From: [Hamish Manzi](#)
To: s22
Cc: s22, s47F
Subject: RE: GMMP
Date: Monday, 18 March 2019 2:13:58 PM

Please see attached the GMMP with a number of edits following our discussion this morning. Edits have been made to sections 3.5.4, 5.3.5.1, 6.2, 7 and Table 45.

Please find attached the Department's feedback on Adani's draft Great Artesian Basin Springs Research Plan (v2) and Rewan Connectivity Research Plan (Revision J).

Figure 1. Groundwater monitoring bores

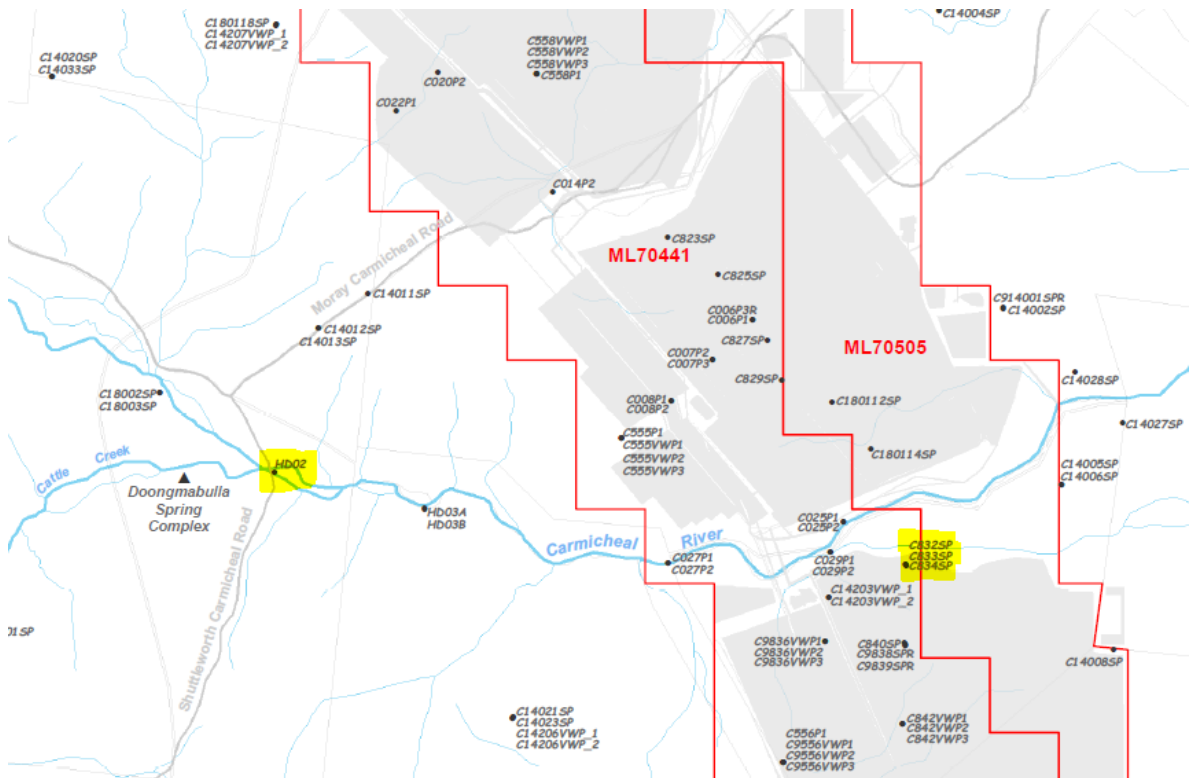
The bore locations are highlighted in Figure 1.

Figure 3. Calibration scatter plot of median 2014-2018 water level measurements after bore re-surveys [$\pm 7m$ bandwidth]

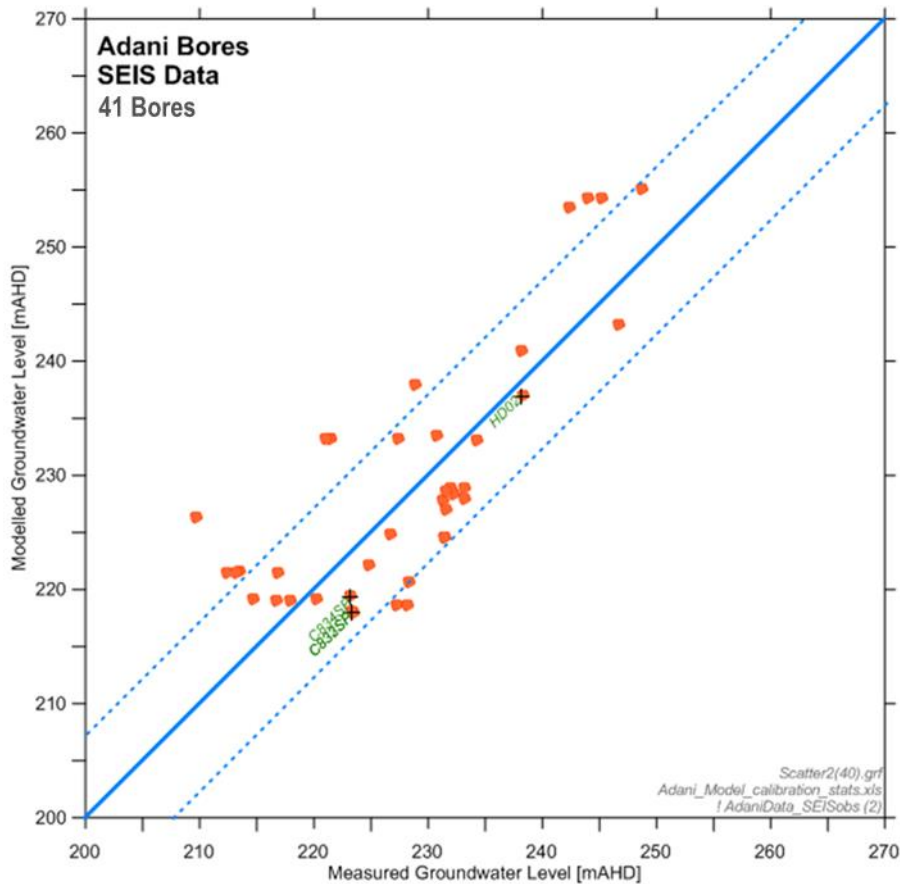
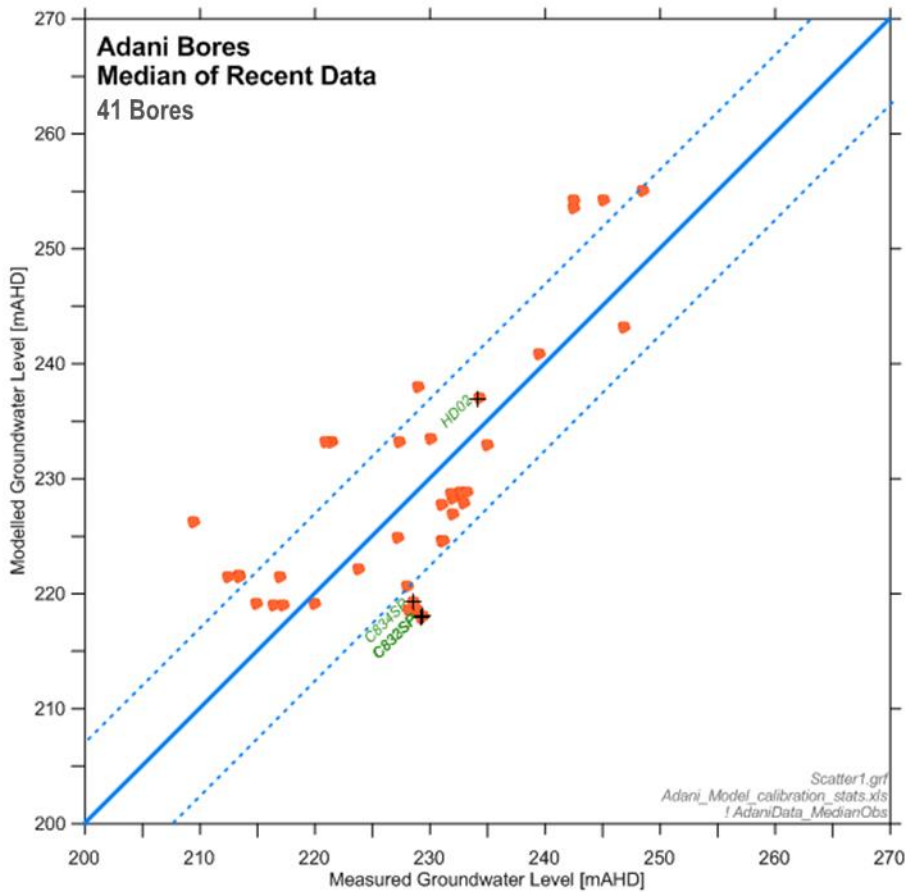
The scatter plots before and after survey correction are shown in Figure 2 and Figure 3 respectively. This shows how HD02 is still well calibrated but the other three bores have drifted out to the edge of the 7 m bandwidth limit.

Figure 4. Calibration scatter plot for Doongmabulla Spring Complex bores for median 2014-2018 water level measurements after bore re-surveys [$\pm 7m$ bandwidth]

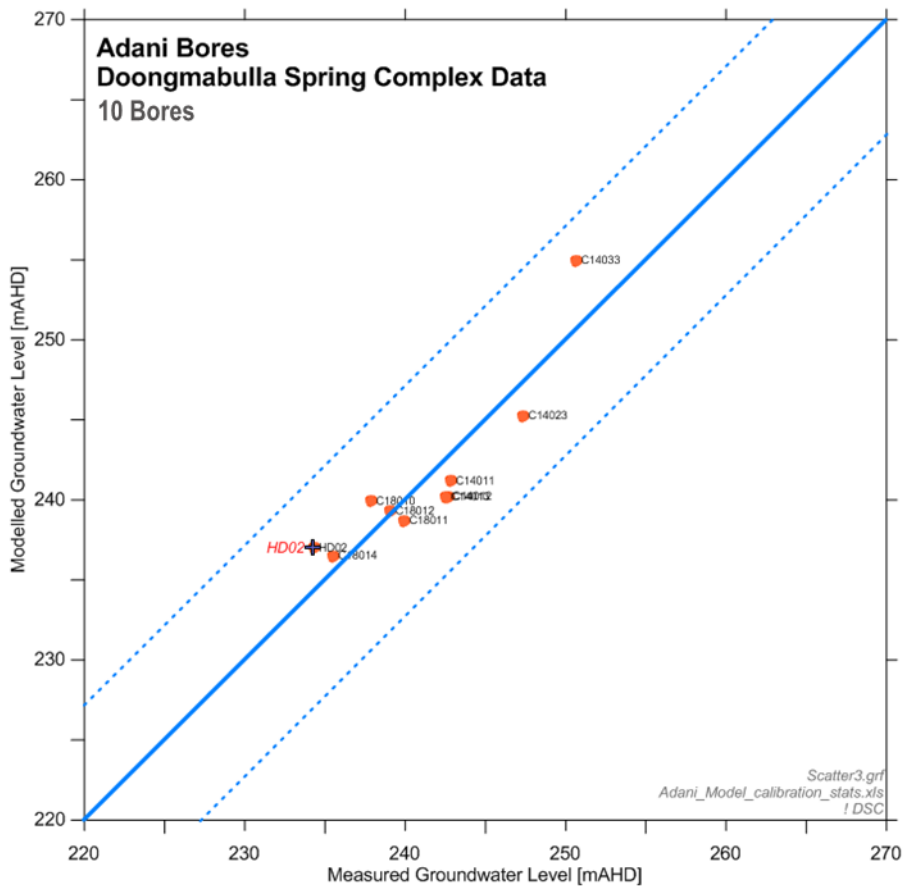
Figure 4 indicates that calibration is very good in the Doongmabulla Spring Complex (DSC) area where HD02 is located. Therefore, the model calibration remains valid and the effect of re-surveying bore HD02 has no material consequence.
